VENDOR SERVICE PUBLICATION

SUBJECT: Oil Pump Impeller and Drive Replacement; AVCO Lycoming Service Bulletin No. 385C dated October 3, 1975 (attached).

Service Bulletin No. 385C
(Supersedes Service Bulletin No. 385B)
Engineering Aspects are
FAA (DEER) Approved

SUBJECT: Oil Pump Impeller and Drive Replacement

Figure 1. Interior View of Accessory Housing Showing
Location of Cotter Pin in Oil Pump Idler Shaft

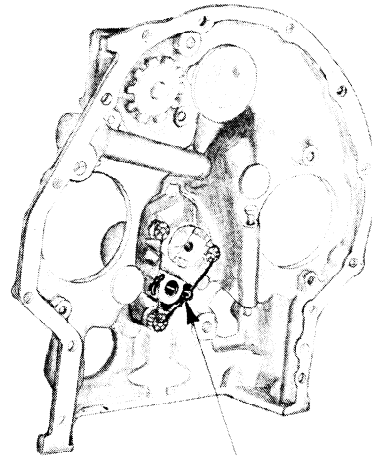
INSPECTION: Applicable remanufactured engines shipped after December 21, 1972 should be inspected to determine if this modification is required: first of all, if the engine log book indicates the engine has not been modified in accordance with Service Instruction No. 1230 or No. 1272, proceed to remove the accessory drive cover from the mounting pad at the lower right side of the accessory housing to obtain access to the area between the crankcase and the accessory housing. On some engines this accessory drive pad is not machined, in this event it will be necessary to remove either the left magneto or the *fuel pump to obtain access to the area between the crankcase and the accessory housing. Regardless of which accessory pad is used, determine if the oil pump idler gear is secured with a cotter pin at the location shown in figure 1. This can be accomplished using an inspection mirror, preferably an illuminated one. If the cotter pin is visible, it is unnecessary to perform the modification required by this bulletin.

IF IDLER SHAFT IS SECURED
WITH A COTTER PIN AT THIS LOCA-
TION MODIFICATION IS NOT REQUIRED

Figure 2. Oil Pump Drive Assembly

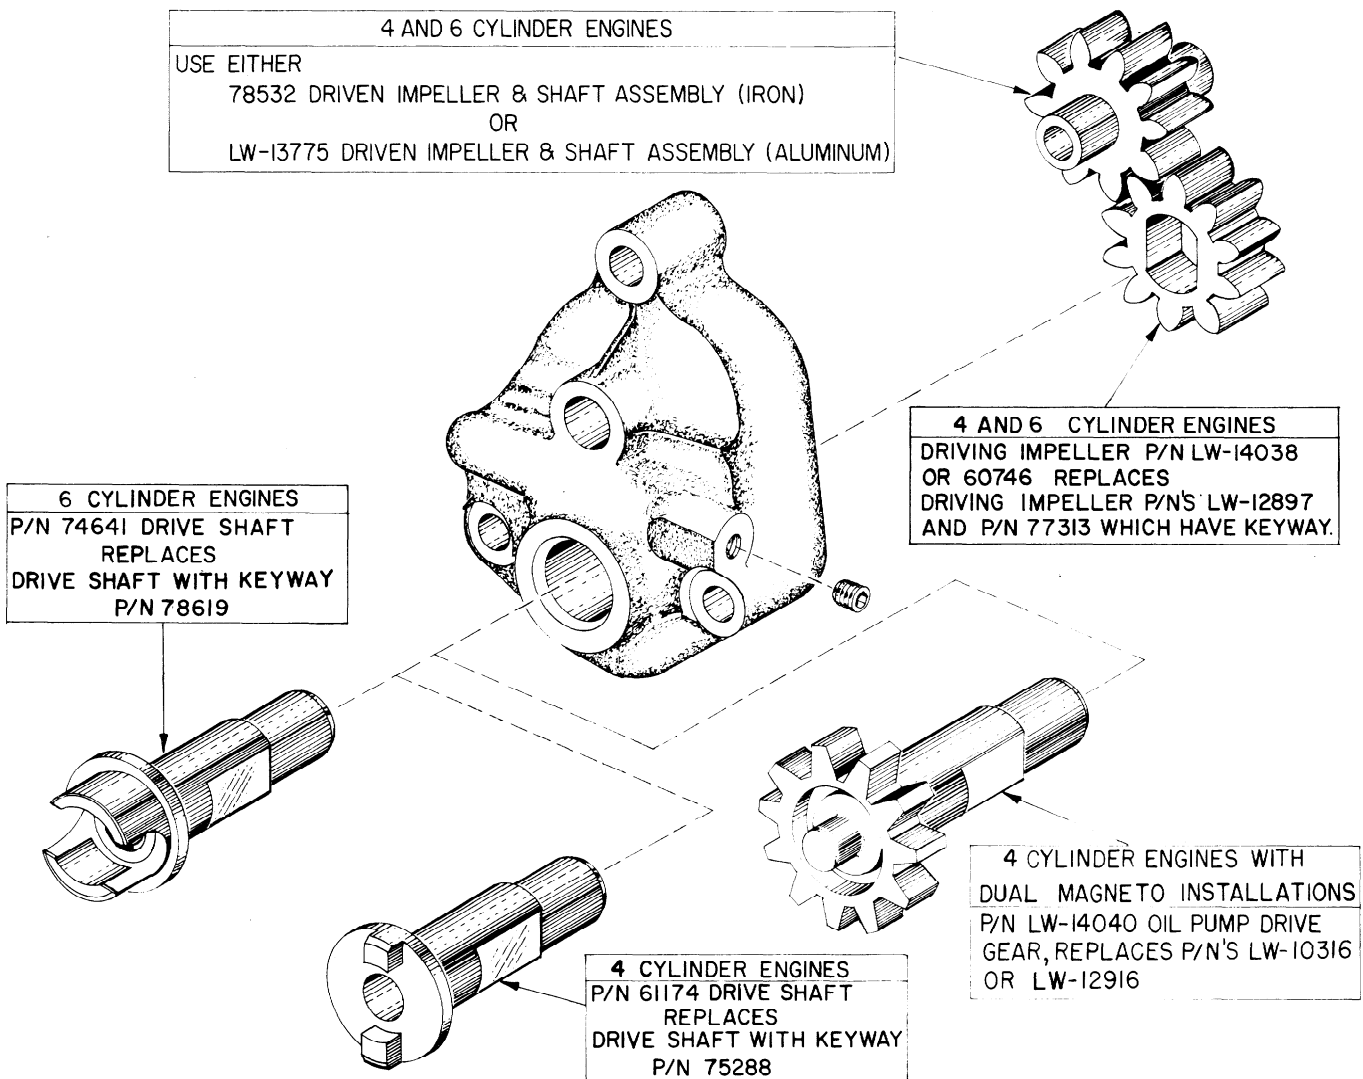
This modification consists of replacing the oil pump drive shaft and drive impeller to eliminate the Woodruff key drive which has proven to be the cause of excessive wear in the keyway of the hardened drive impeller. Therefore, it is recommended that all of the applicable engines listed in the chart, as well as any others that may have been modified in accordance with Service Instruction No. 1272, use the following procedure for parts replacement.

3. Reassemble the oil pump using the new drive shaft and drive impeller supplied with the kits shown in the following "Parts Data" section. See figure 2. Be sure all of the parts are lubricated thoroughly during assembly.

LW-14129	Gasket Kit, Oil Pump Shaft Replacement (4 cylinder engines) consists of: (1) 60096 fuel pump gasket, (3) 62224 magneto gasket, (1) 73818 accessory housing gasket, (2) LW-12681, -1200 series magneto gasket, (1) LW-13353 oil sump gasket
LW-14130	Gasket Kit, Oil Pump Shaft Replacement (6 cylinder engines) consists of: (1) 60096 fuel pump gasket, (3) 62224 magneto gasket, (1) 73818 accessory housing gasket, (2) LW-12681, -1200 series magneto gasket, (1) LW-14128 oil sump repair gasket
LW-14131	Oil Pump Shaft Replacement Kit (4 cylinder engines) consists of: (1) 61174 oil pump drive shaft, (1) LW-14038 or 60746 drive impeller
LW-14132	Oil Pump Shaft Replacement Kit (4 cylinder, dual drive magneto engines) consists of: (1) LW-14040 oil pump drive gear, (1) LW-14038 or 60746 drive impeller
LW-14133	Oil Pump Shaft Replacement Kit (6 cylinder engines) consists of: (1) 74641 oil pump drive shaft, (1) LW-14038 or 60746 drive impeller
